Department of Public Works  
**Engineering Division**  
Robert F. Phillips, P.E., City Engineer

**NOTICE OF ADDENDUM:  
ADDENDUM 1**

**CONTRACT NO. 7850  
YUMA DRIVE RESURFACING ASSESSMENT DISTRICT - 2017**

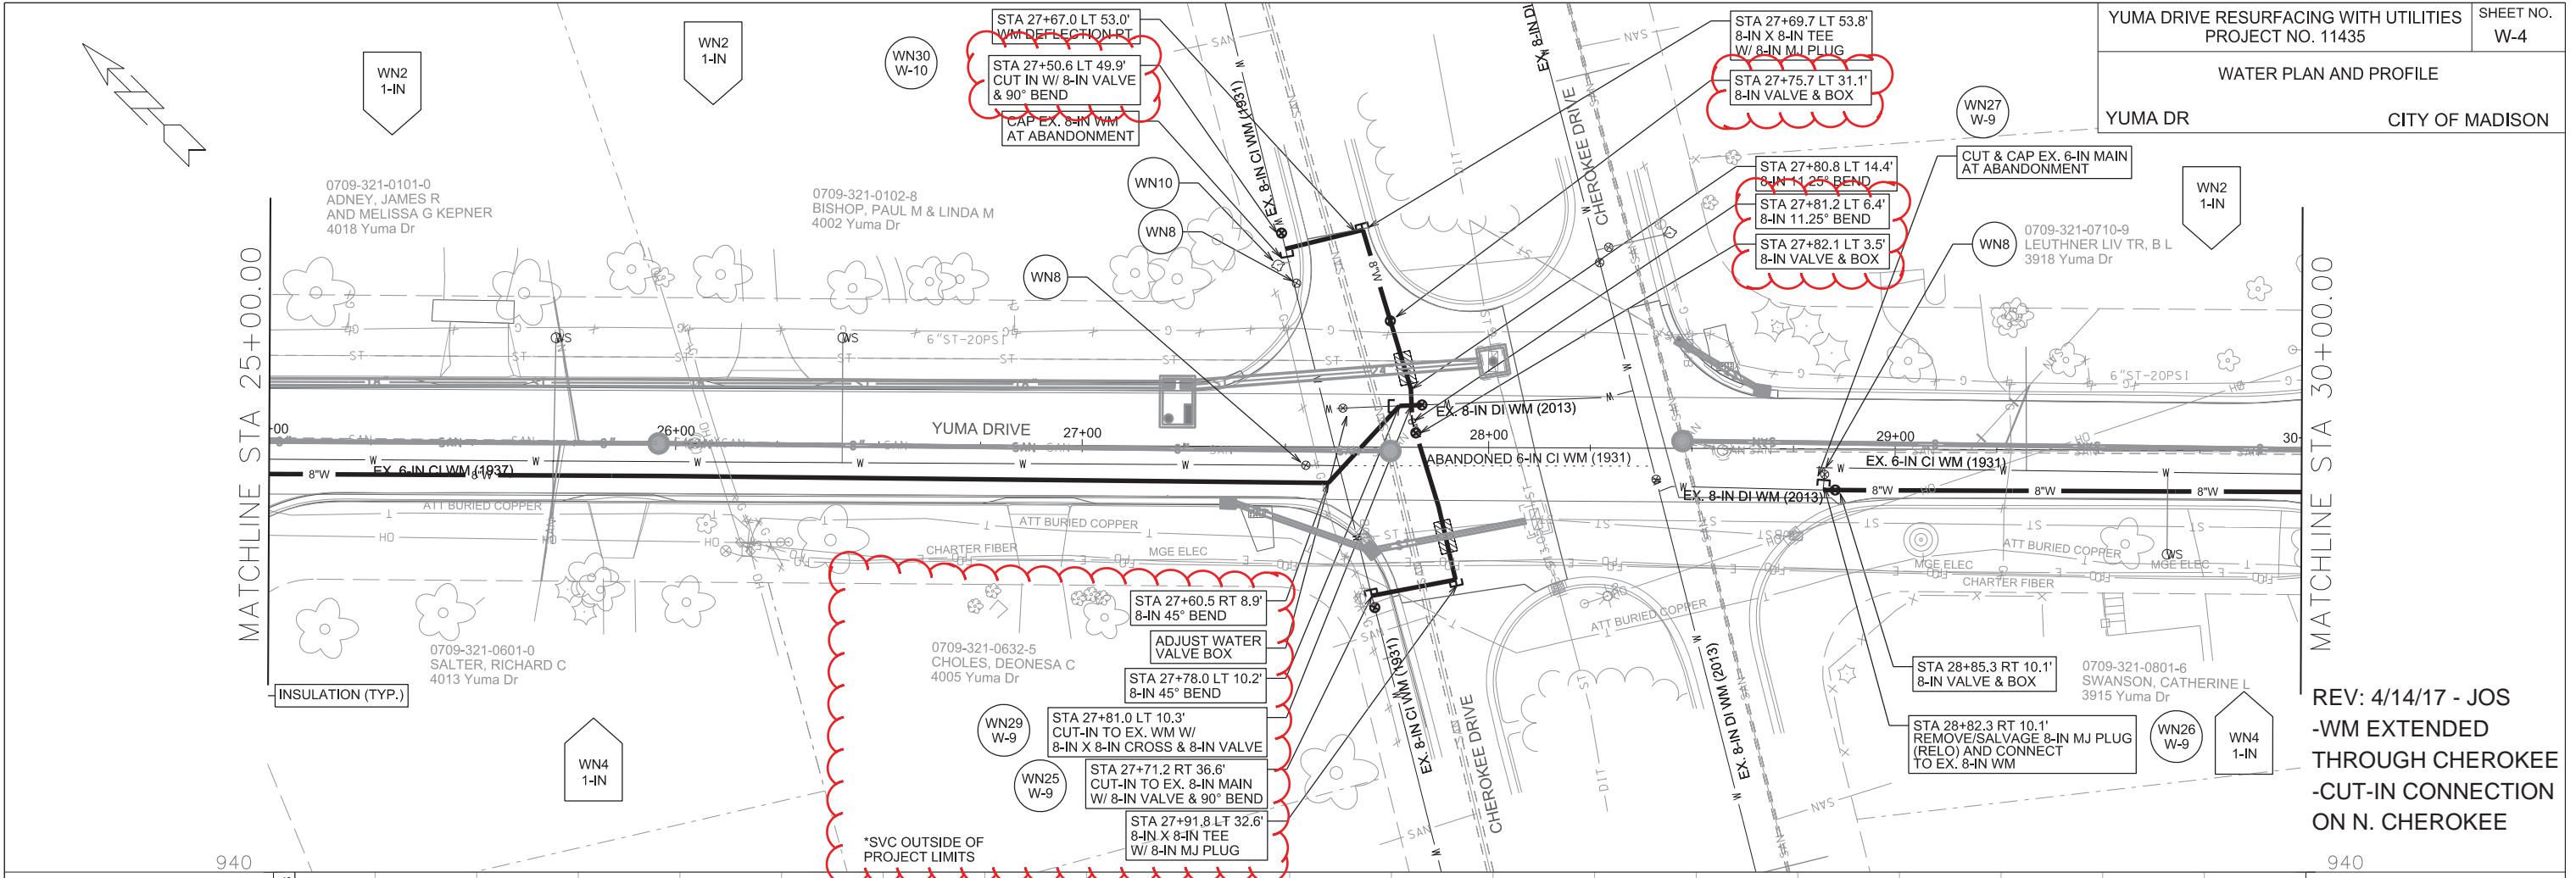
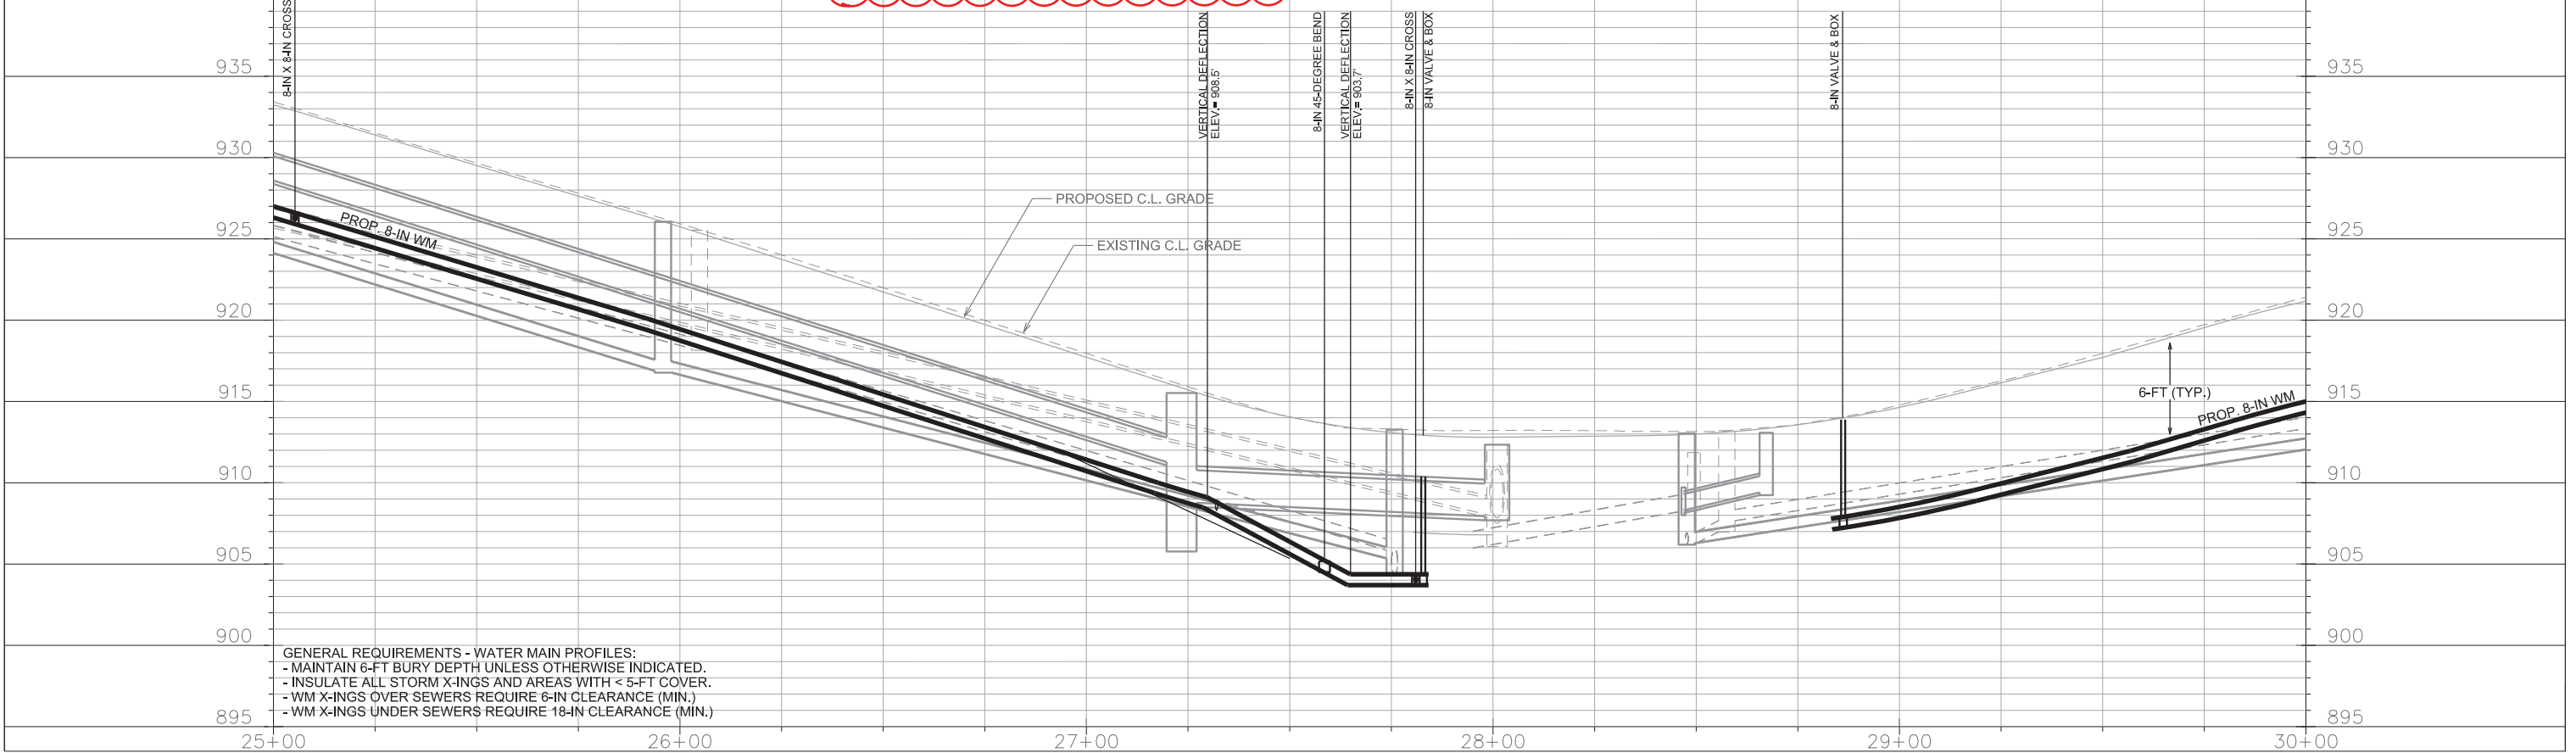
REV: 4/14/17 - JOS  
-WN2 AT 4108 YUMA  
-8-IN VALVES AT YUMA  
HIAWATHA INTERSECTION  
(2)

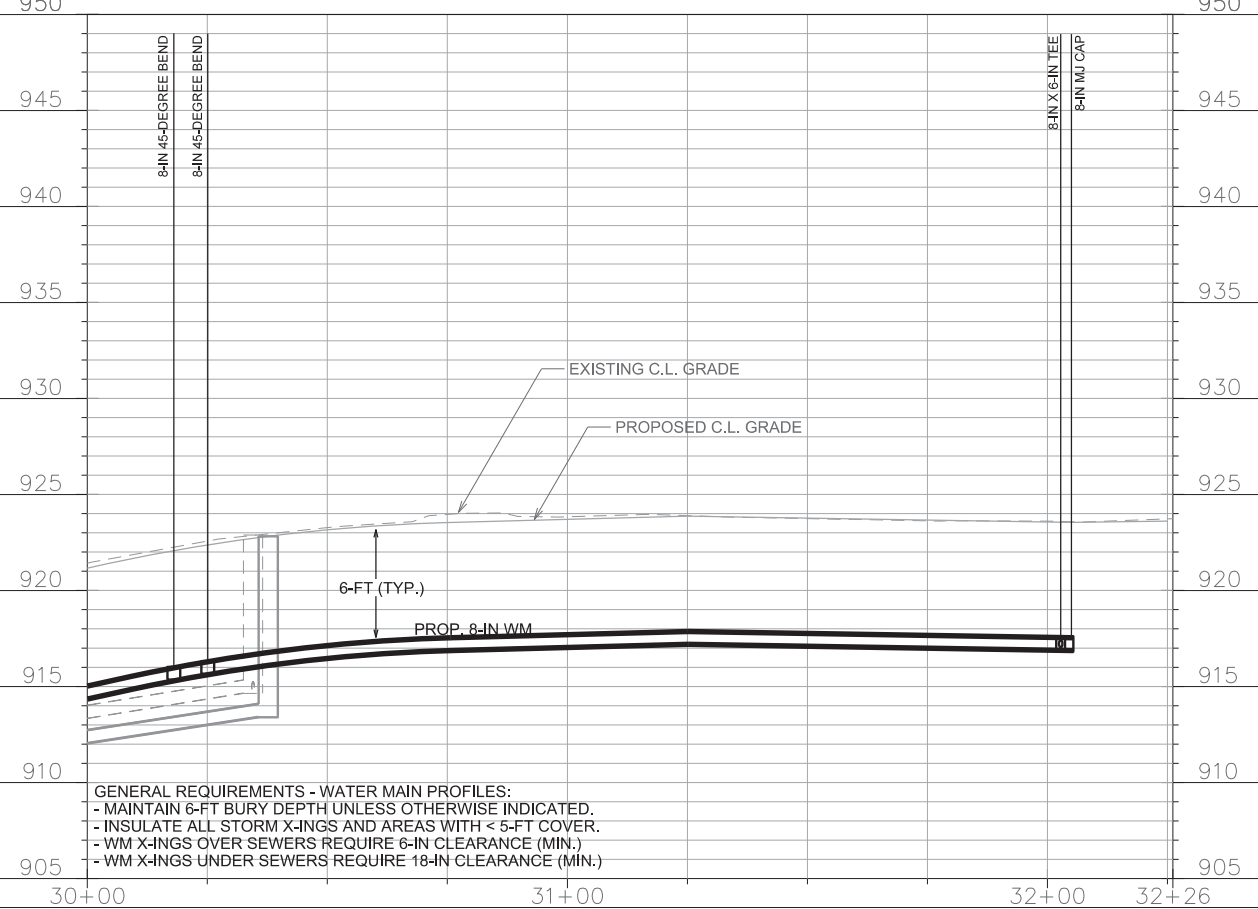
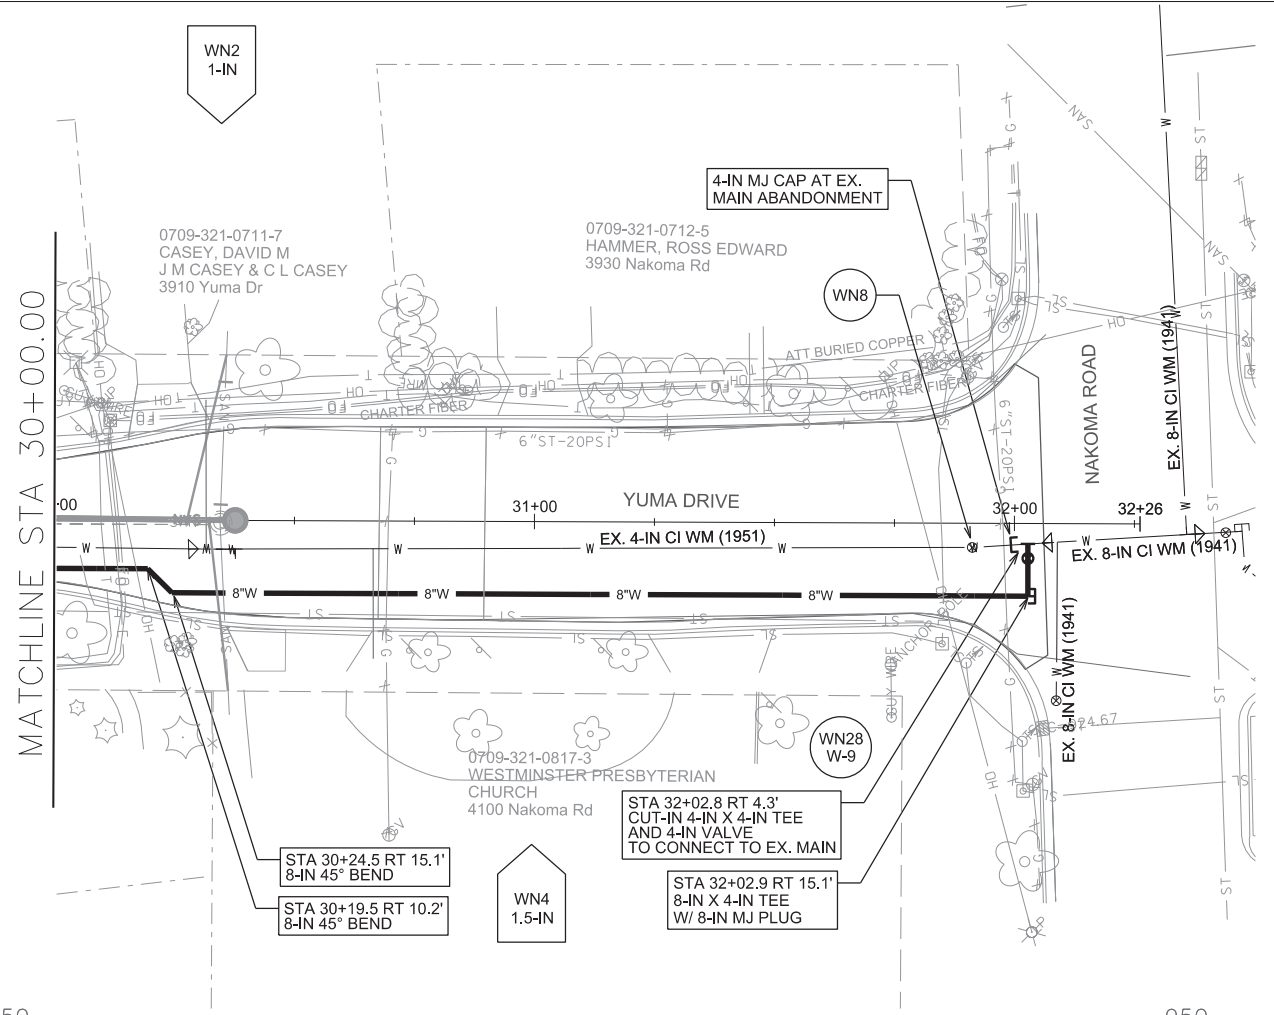
REV: 4/14/17 - JOS  
 -WM EXTENDED THROUGH CHEROKEE  
 -CUT-IN CONNECTION ON N. CHEROKEE
